TDG Ref: 13725  
27 October 2016

## **Shelly Bay Masterplan Response to Further Information Request – Transportation Matters**

Wellington City Council's letter of 7 October 2016 seeks further information in response to the Resource Consent application for the mixed use development within the area known as Shelly Bay. Included below are the relevant traffic and transportation matters raised, along with our response to the further information requested.

**Figure 1: Hourly Traffic Counts for Shelly Bay Road**

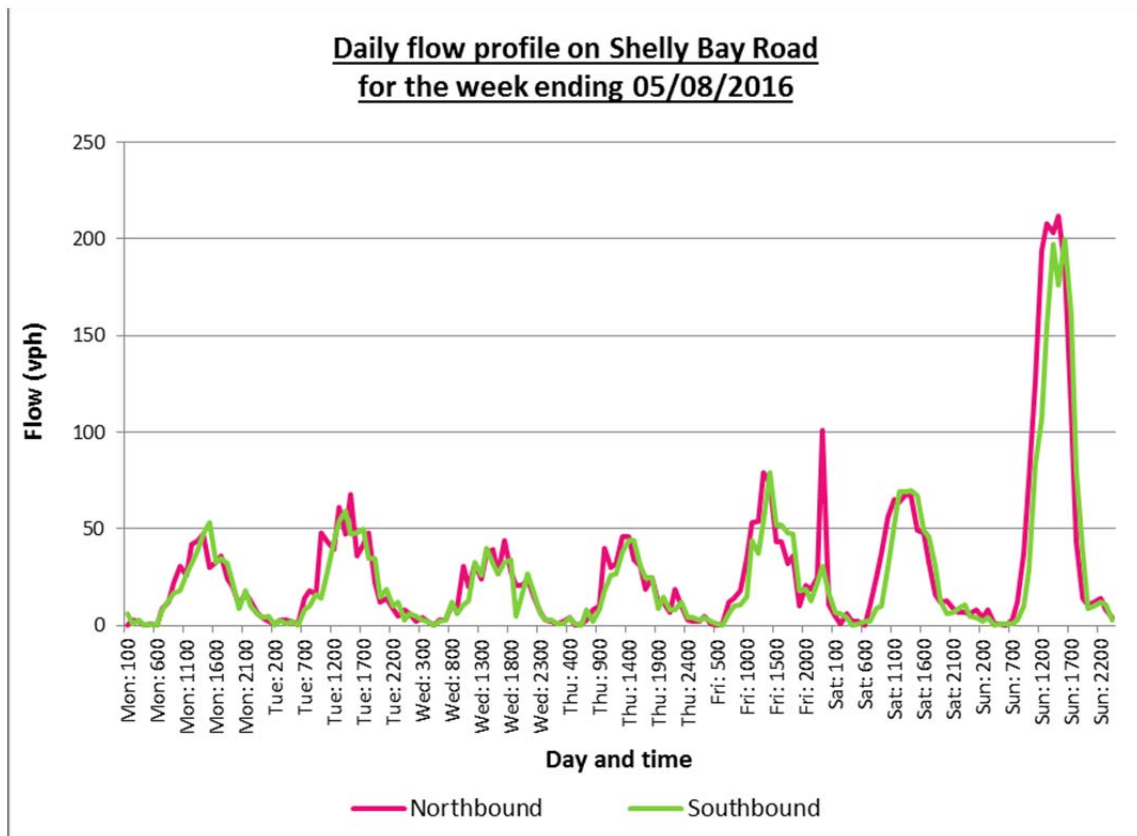
*The TDG report includes hourly traffic volumes through the day, however, it's not clear if these figures are weekday averages or include weekends. Separate information on weekdays and weekends (Saturday and Sunday separately) will need to be provided.*

Figure 2 of the September 2016 TDG TAR shows the average 7-day traffic volume profile. **Figure 1** below provides the hourly traffic volume profiles (separated by direction) recorded by tube counter on Shelly Bay Road, some 500m north of Miramar Avenue, during the 1<sup>st</sup> week of August 2016.

As shown, the volumes on Sundays are somewhat higher than those recorded during the rest of the week, representing the recreational function that Shelly Bay Road serves outside of the traditional commuter peak periods.

APPENDIX A

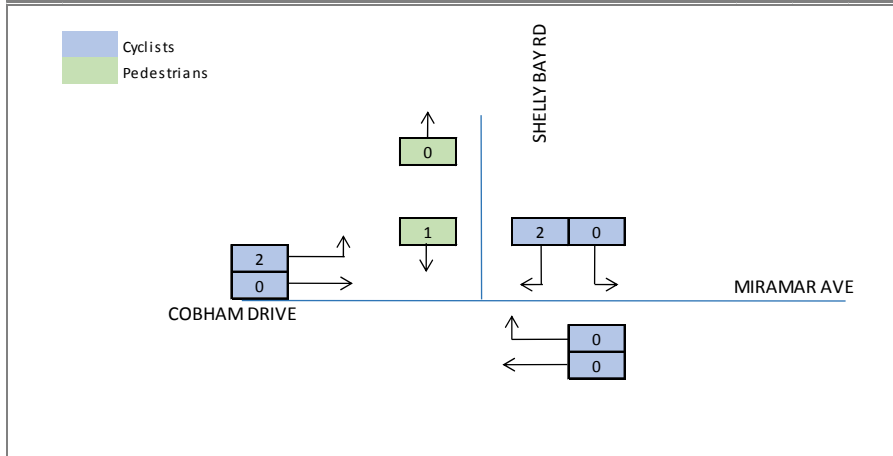
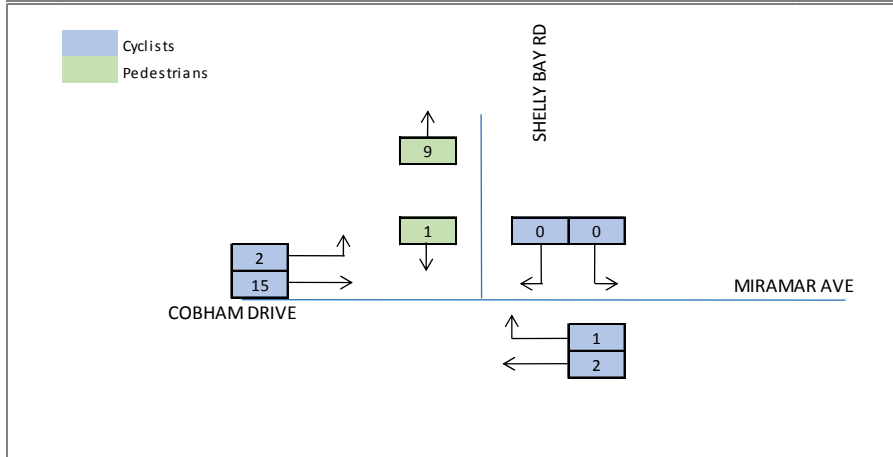
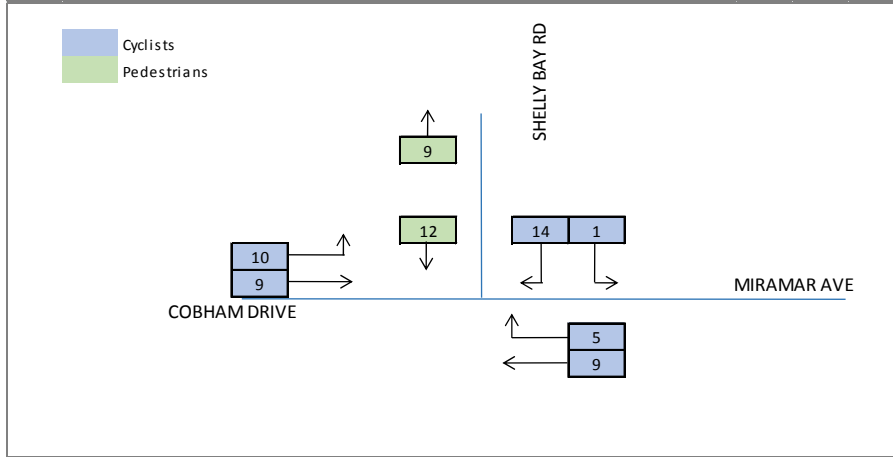
**Pedestrian and cycling numbers using Shelly Bay Road, current and projected, will need to be provided.**

**Appendix A** provides the existing cycle and pedestrian volumes in the vicinity of the Shelly Bay Road / Miramar Avenue intersection (provided by Council), for a weekday AM, IP, PM, and Saturday midday peak hour, as recorded in May 2016.

The survey count data in appendix A indicates that no cyclists were recorded either entering or exiting Shelly Bay Road during the weekday AM commuter peak hour, whilst a total of 4 and 3 cyclists were observed on this part of Shelly Bay Road during the weekday midday and PM peak hours, respectively, on the day of the survey. Data for the Saturday midday peak hour period shows a total of 30 cyclists turned either into or out of Shelly Bay Road, at the Miramar Avenue intersection, which again represents the recreational function of the route. The pedestrian volume data indicates 1 or 2 individuals using the Miramar Avenue end of Shelly Bay Road during the weekday morning and lunchtime peak hours, whilst some 10 and 21 pedestrians were observed during the weekday PM and Saturday midday peaks, respectively, with a proportion of these likely to be using the footpath connection that leads up to Aranui Street.
